SUBJECT: 10 CFR 71.95 Report on the 8-120B Cask
Palisades Nuclear Plant
Docket No. 50-255
License No. DPR-20

ENERGYSOLUTIONS 10 CFR 71.95 REPORT ON THE 8-120B CASK

**Failure to Observe Certificate of Compliance Conditions
for the 8-120B Vent Port Pre-Shipment Leak Test**

Details of the 8-120B Vent Port Leak Rate Test Setup

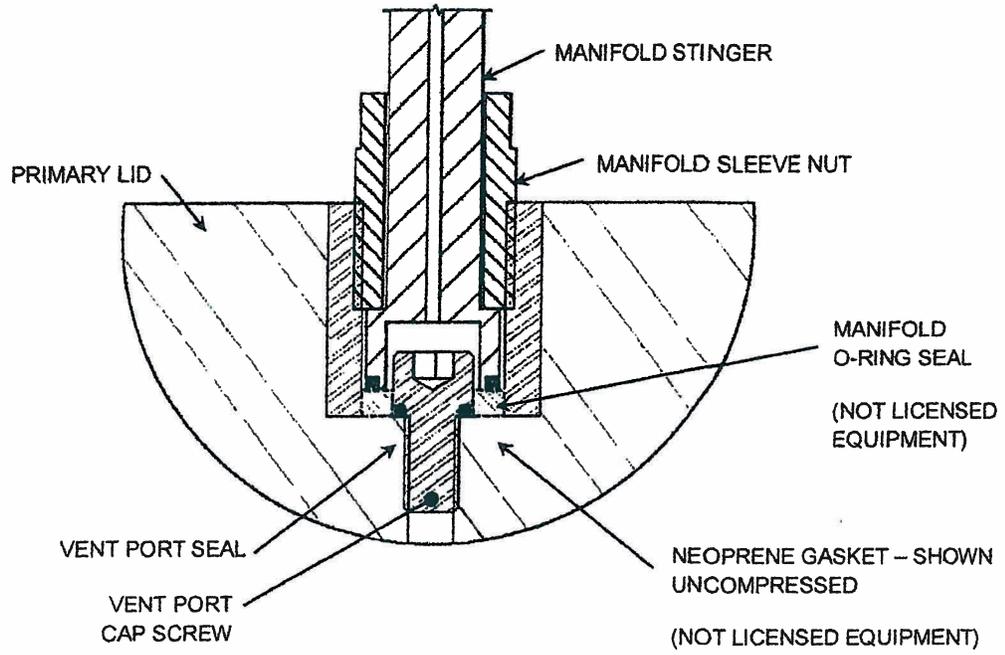
The neoprene gasket can constrict on the head of the vent port plug cap screw when it is compressed by the bottom end of the test manifold stinger, which could reduce the sensitivity of the pre-shipment leak test. Consequently, the vent port pre-shipment leak tests performed using the neoprene gasket may not have provided the required test sensitivity of 1×10^{-3} ref-cm³/sec.

The pre-shipment leak test of the vent port is a pressure drop test performed using a dedicated test manifold. The test manifold is not a part of the licensed package. It includes a stinger (shown below), an O-ring seal that contacts the stinger and the bottom of the vent port hole, and a sleeve nut to compress the O-ring seal. The test manifold was designed so that it surrounds the vent port cap screw, leaving a small gap between itself and the vent port cap screw. The 8-120B cask fleet began to ship with a new lid design in September 2013, and operations staff noted more frequent difficulty getting the manifold to seal. It became desirable to find a better way to seal the bottom of the manifold in order to minimize operator exposure. They found that adding a neoprene gasket (also not part of the licensed package) under the base of the stinger as shown below helped reduce testing time and exposure.

Corrective Action – Modified Test Seal

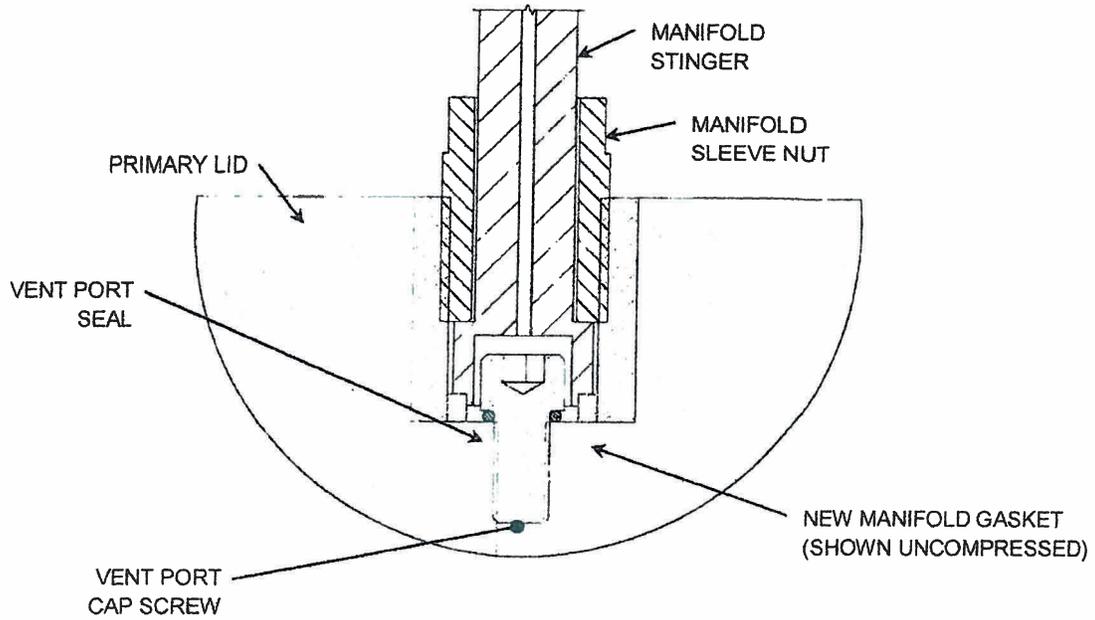
The new manifold gasket design, shown below, replaces the manifold O-ring seal and neoprene gasket previously used with a neoprene gasket that fits within the notch at the base of the manifold stinger.

- *EnergySolutions* designed and tested new manifold gasket design that does not constrict onto the head of the vent port plus screw when compressed, and therefore it does not reduce the test sensitivity. The new gaskets have been distributed to all upcoming shipment users. The new manifold gasket design is shown in Attachment 1. The *EnergySolutions* drawing for the 8-120B air drop manifold have been revised to include the new gasket seal, and the air pressure drop test procedure TR-TP-002 has been revised to incorporate the new pre-shipment leak test procedure for the vent port. Use of the new procedure and the new manifold gasket will assure that the pre-shipment leak test satisfies the required test sensitivity and that the manifold gasket is removed from the test port after completing the pre-shipment leak test.
